Product Change Notification - IIRA-29UYPT414

Notification subject: CCB 1375 Final Notice: Qualification of all EcqoLogic products in the 16L QFN (4x4) package at NSEB (UTL) assembly site and changes to marking, packing & catalog part number (CPN) convention.

**PCN_IIRA-29UYPT414_Pre and
Post Change**

Package Top Marking

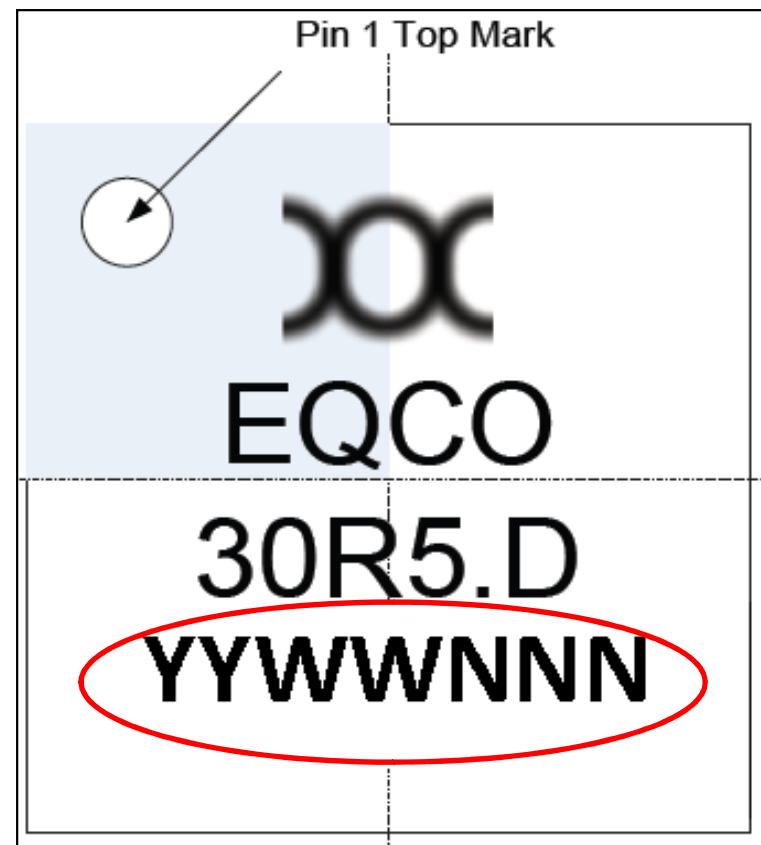
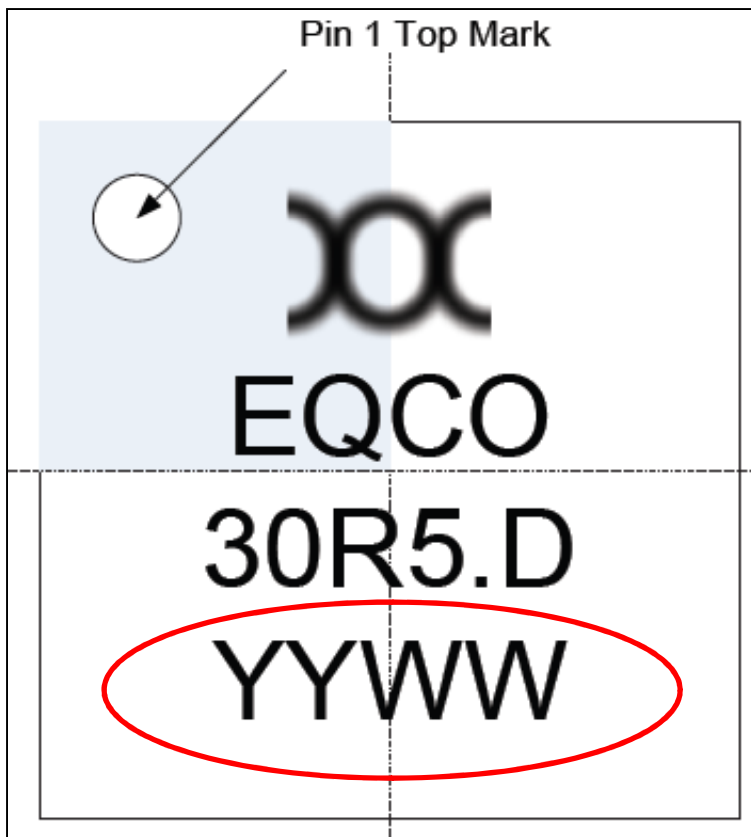
Pre Change: Traceability Code is YYWW

Post Change: Traceability Code is YYWWNNN
